Camp Oakdale Lake Excavation

Review Date: September 27, 1990

**ENVIRONMENTAL REVIEW TEAM REPORT
ON
CAMP OAKDAKLE LAKE EXCAVATION
MONTVILLE CONNECTICUT**

WATERSHED BOUNDARY MAP

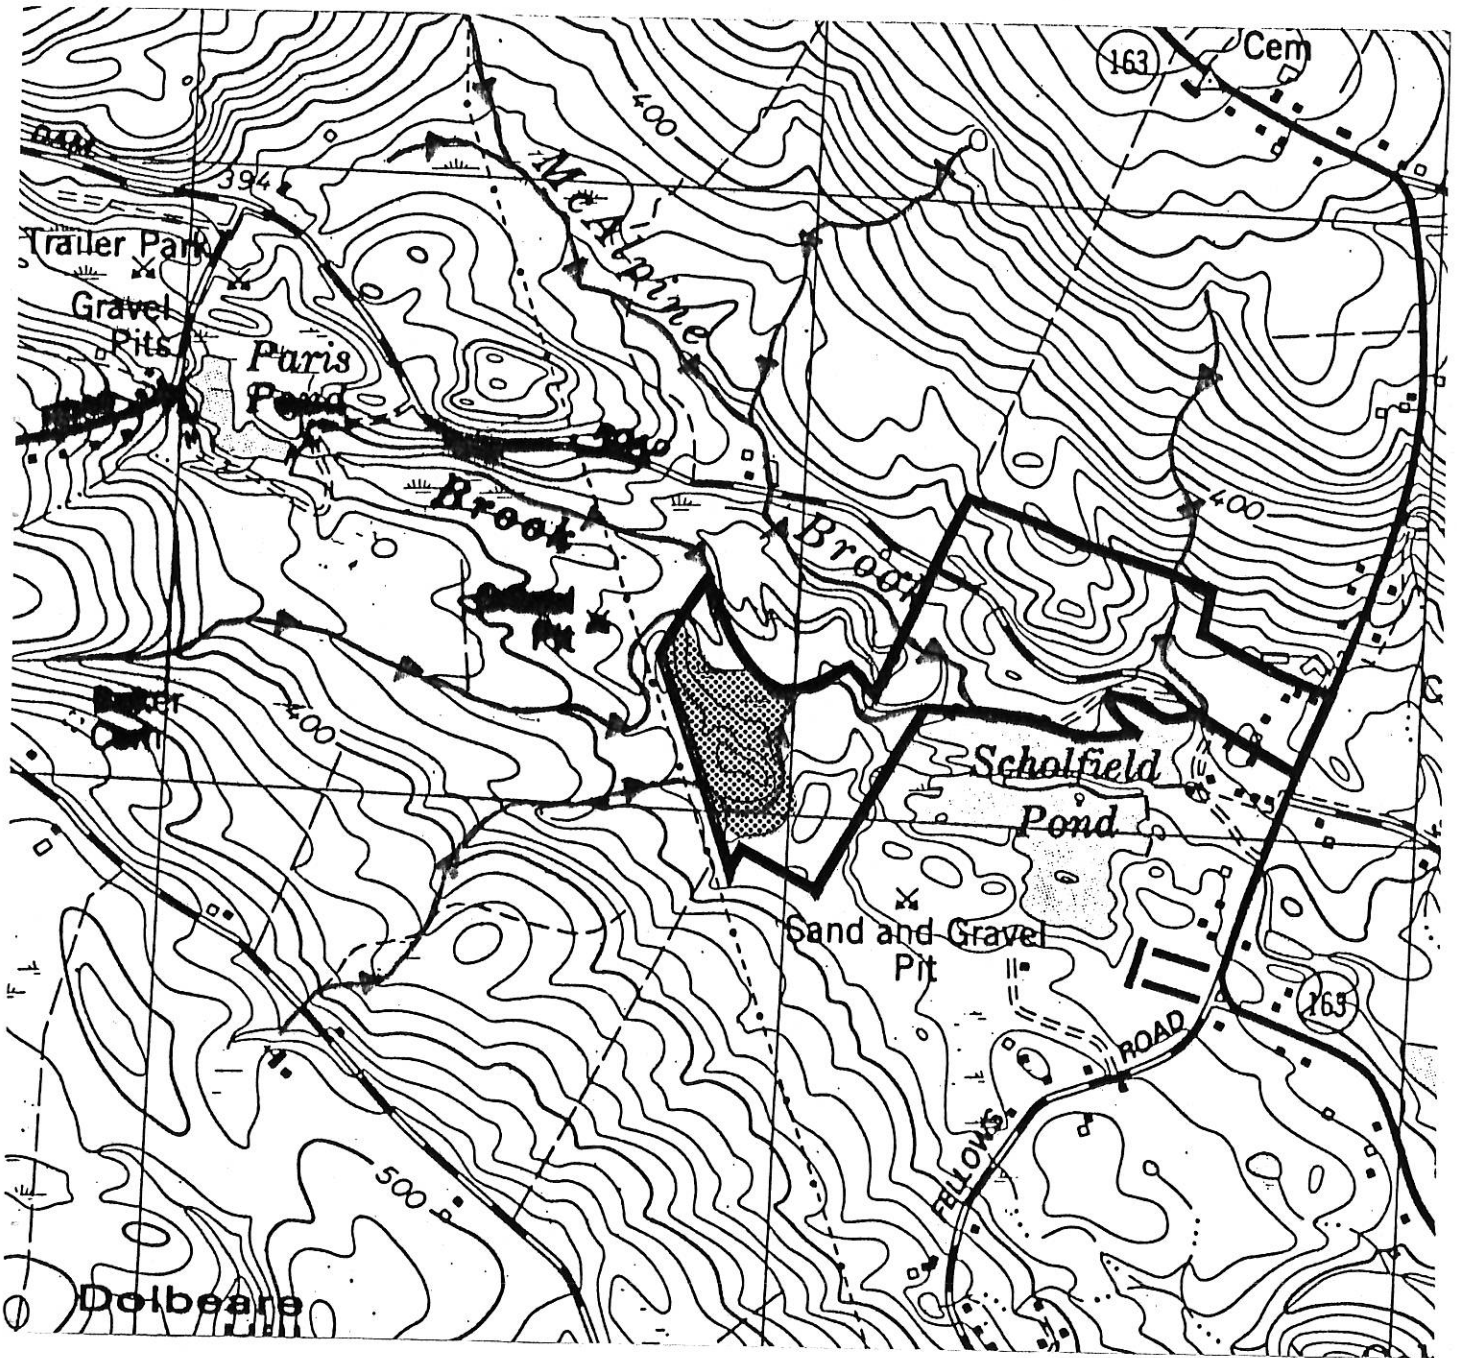
- 3) Based upon a calculation of the contributing watershed the present proposal will require a Water Diversion Permit from the DEP, Inland Water Resources Division. The preliminary design receives water from approximately ± 205 acres of watershed and intercepts two watercourses. If the Town of Montville should have questions concerning Water Diversion Permits they should contact Mr. Bob Gilmore at 566-7160.
